CONDITIONS FOR DONATION

Project: Washington Street Improvements Parcel 17A & 18

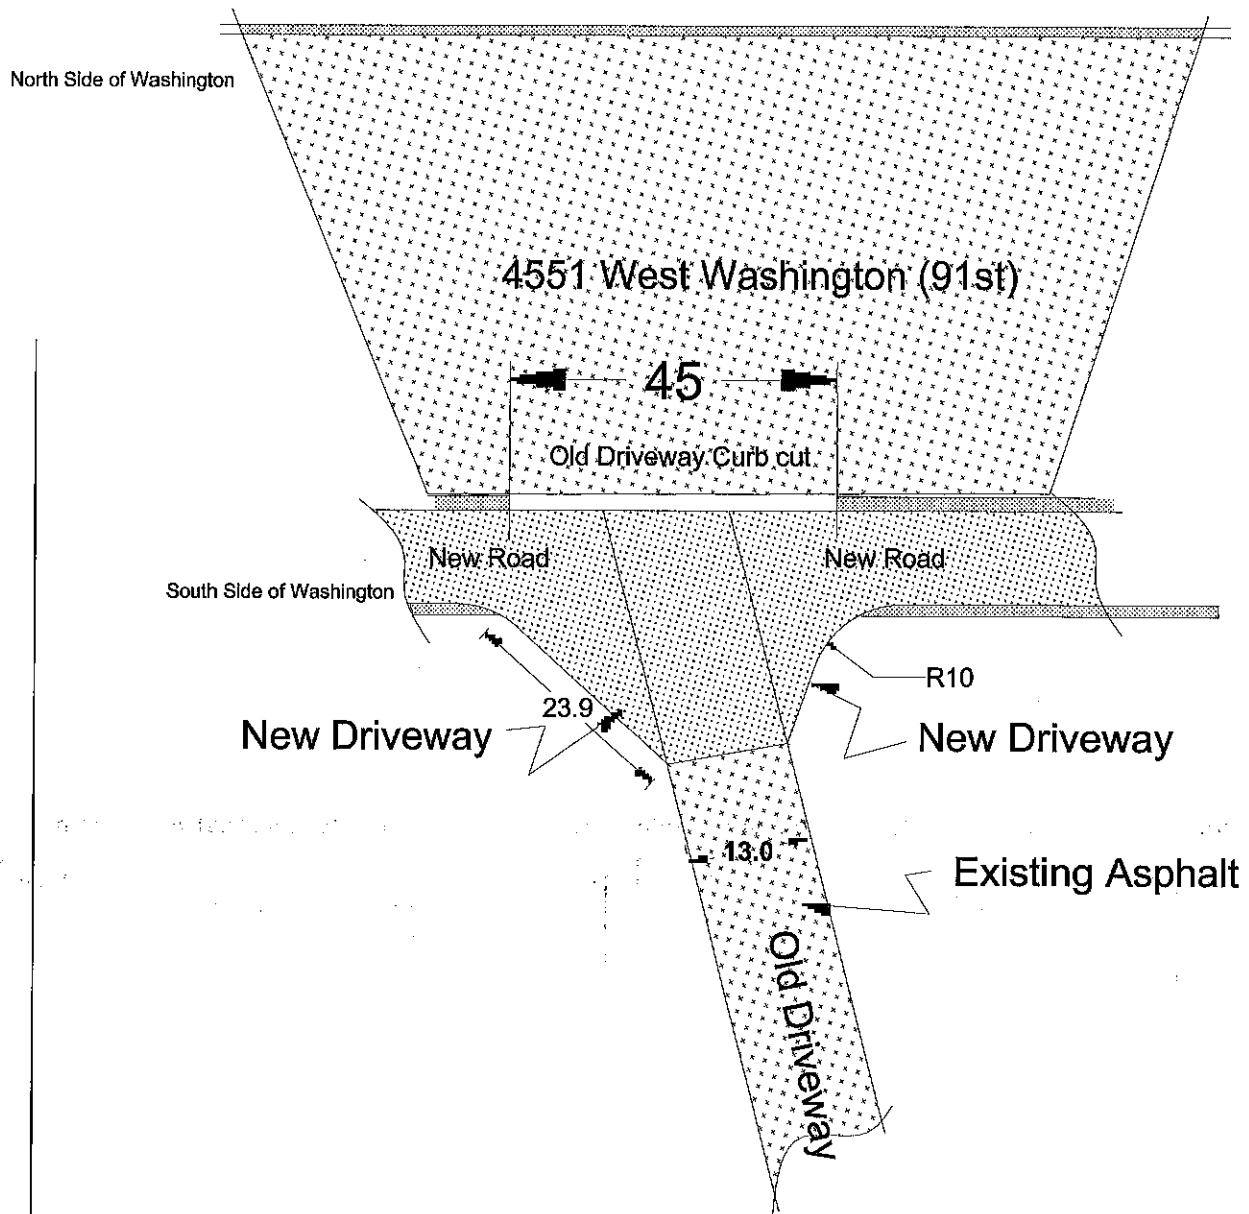
1. Replace fence with like or better: Current fence has two each 12-foot-wide double gate (24 foot opening), one west side (215+50), one east side (222+35) of drive way. The Gate support post are double 7-inch wood support post with cross brace for each gate hinge and at the end of each fence run for a total of eight double support ends (total 16 post). Replace with new or equivalent fence end supports. Install new or equivalent gates or reuse the existing gates.

2. Place a minimum of 4' chain link fence around the culvert trio (STR RCP2 214+00) and tie to the existing fencing for safety.
3. Place temporary fencing when existing fence is removed during construction.

4. Main Driveway entrance replacement: 50' curb cut as it is presently, driveway concrete thickness minimum 6 inch, 8" compacted gravel base under driveway with no mountable curb or curb bump to allow street runoff flows to pond. Must support loaded trash truck.

5. Replace the other two driveways, as they exist presently. The driveway in alignment with the pond will not have a hump in it.

4501 West Washington

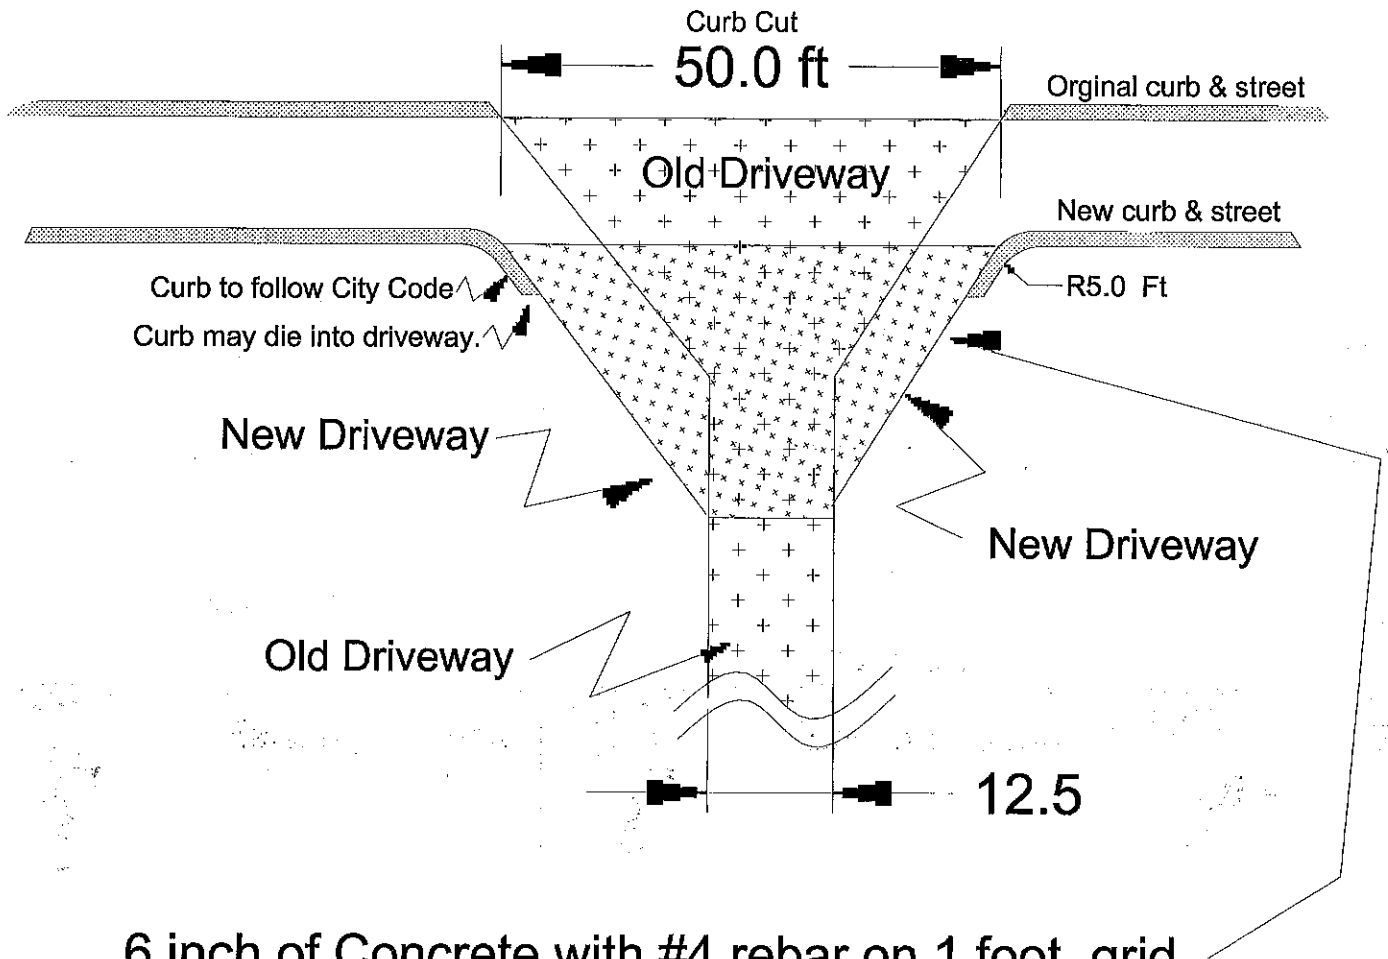
1) Please make new curb cut at least 45 ft

The existing curb cut is not nicely finished but does allow a vehicle with RV to turn out without damage.

6 inch of Concrete with #4 rebar on 1 foot grid

Compact 8" gravel base

Must Support Loaded Trash Truck

No Curb bump since any street runoff flows to pond
